HDC-2025-00012

Address: 625 Liberty Street

District: Old Fairgrounds Historic District

Proposal: Replace rooftop railing, install deck and door and lighting at existing signage.

Annotated image indicating extent of proposed roof deck, uncovered door opening (left), and proposed infill for window (right) (Applicant)

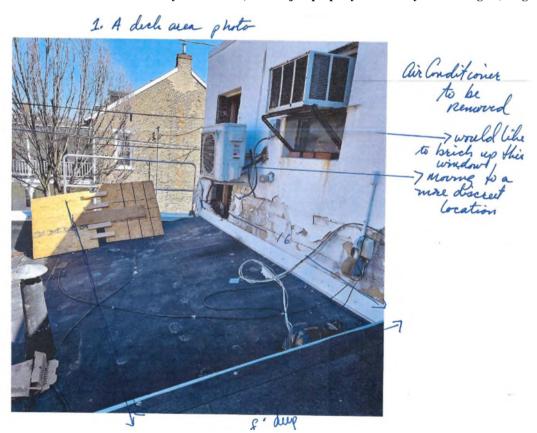
- **Rear Railing:** If approved, it would be preferred for the existing metal pipe railing to be removed and replaced with the wood railing; having both may be redundant. Installing a wood rail would create balance on the streetscape, as on the other side of Park Street, 623 Liberty has a rear second floor porch with wood railing. More information would be helpful to understand the proposed extent of the proposed railing would it go the length of the deck, or the whole length of the exterior wall? It would be appropriate/preferred for the railing to extend the length of the deck.

- **Roof Deck:** The extent of the proposed deck (8' from the rear wall) is in proportion with other typical historic rear balconies and porches.
- **Proposed Door:** A full view fiberglass door in a previous doorway is appropriate per the guidelines. A full-light storm door is also appropriate.

- **Proposed Window Infill:** The second window at the rear is a replacement window in an opening that had been previously reduced from its original size. Given the extent of exterior modifications and alterations on the entire structure, infilling this window would not have a negative effect on the streetscape.

- The wood railing replaces the existing pipe railing (as allowable by code official), and extends the length of the deck.
- The second floor window infill is finished in such a way as to match the finish of the exterior wall around it.
- Sign light fixture is a simple fixture directed only at the sign, avoiding excessive illumination of areas outside the sign, and fixture information is submitted to staff for approval.
